**RESPONSE TO SUBMISSIONS  
FOR CEMENT AND SLAG  
RECEIVAL AND DISPATCH  
TERMINAL, MAYFIELD NORTH**

Prepared by  
Umwelt (Australia) Pty Limited  
on behalf of  
Independent Cement & Lime Pty Ltd

Project Director: **Peter Jamieson**  
Project Manager: **Rod Williams**  
Report No. **2520/R09/Final**  
Date: **April 2013**

FIGURE 2.1

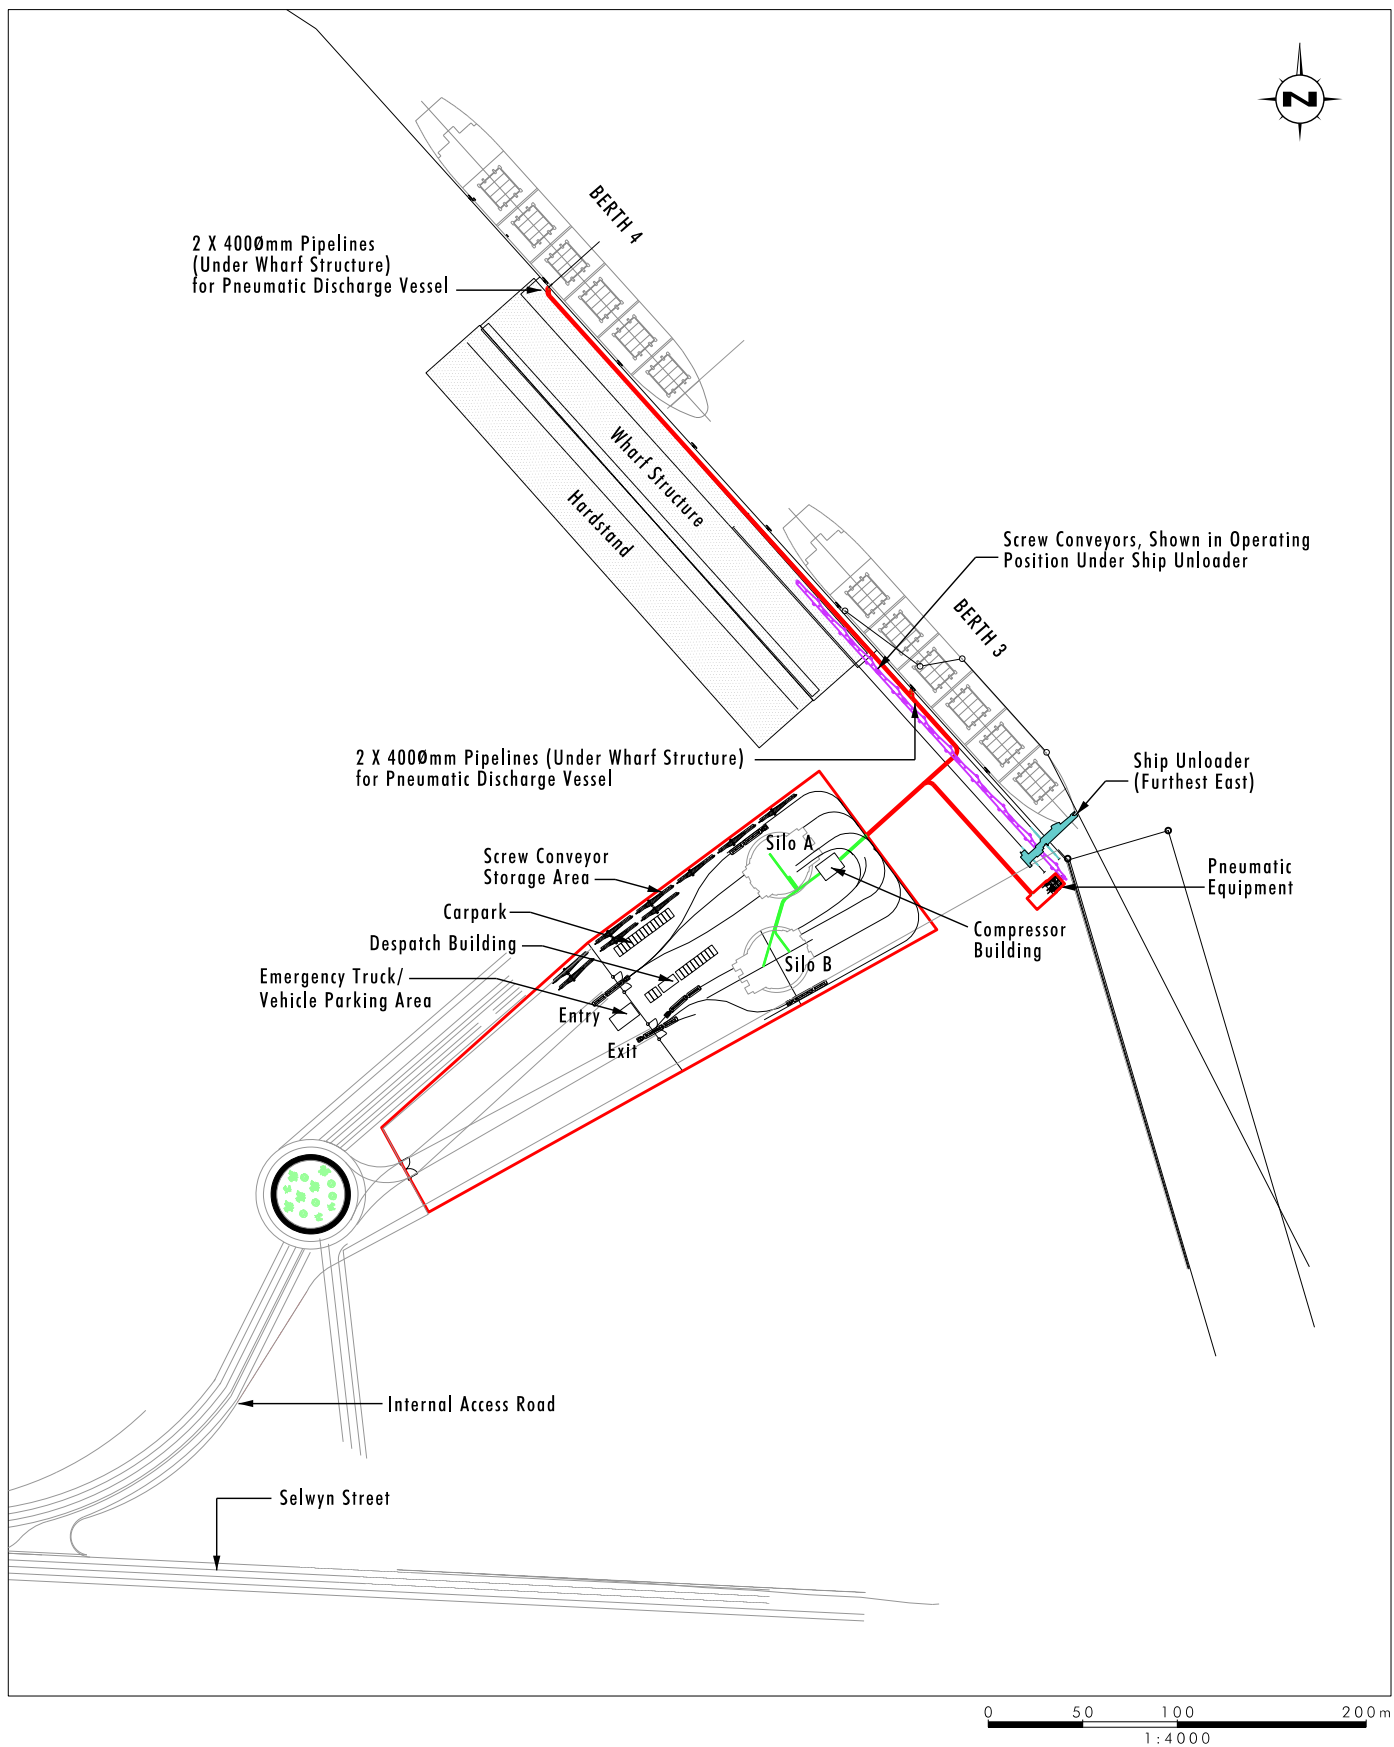
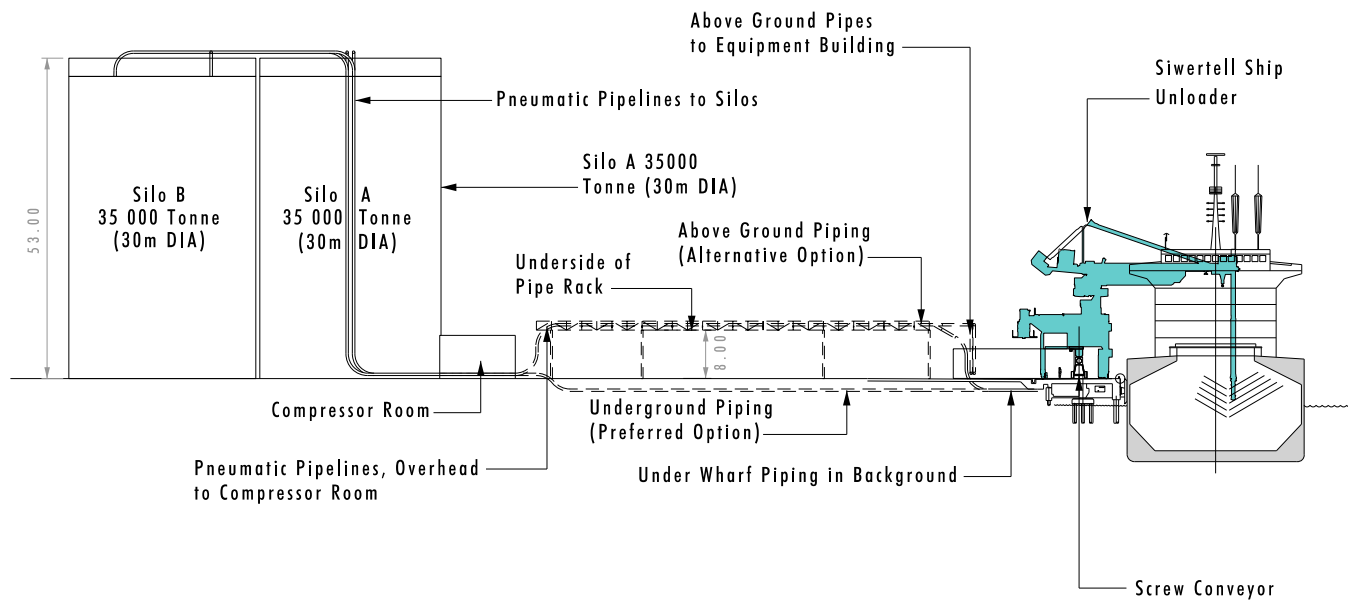
### **Construction of a dedicated emergency truck parking area within the site.**

**In Figure 2.1 of the EA there is a section of piping that is shown as above the wharf (Mayfield Wharf Silo South-East View). NPC require all links to the boundary of its leased area to be underground (excluding the mobile conveyors/augers).**

**The EA indicates that the truck route will be via Selwyn St until such time the NPC has developed the Mayfield Concept Plan access roadway and from that time the new road will be used. Advice from the NPC is that the new roadway is under construction and should be available for use by the third quarter 2013. The NPC current thoughts on roadway use do not seem to be consistent with the initial roadway proposal for the concept plan.**

The Project includes a dedicated emergency truck parking area within the site (refer to **Figure 2.1** of the EA attached).

The establishment of the permanent access points and internal road network within the closure area is the responsibility of NPC. The permanent vehicle access point to the site will be via Selwyn Street. The internal access road arrangement it its connection with Selwyn Street is shown on **Figure 2.1** of the EA (attached).

The permanent internal access road arrangement and its connection with Selwyn Street has been provided to ICL by NPC and is shown on Figure 2.1 of the EA (attached). The issue of the internal roadways being inconsistent with the Concept Plan is a matter that NPC needs to consider and address, as it is outside the scope of this Project. The internal road network was approved as part of NPC's Mayfield Concept Plan Approval and is therefore the subject of a separate approval.
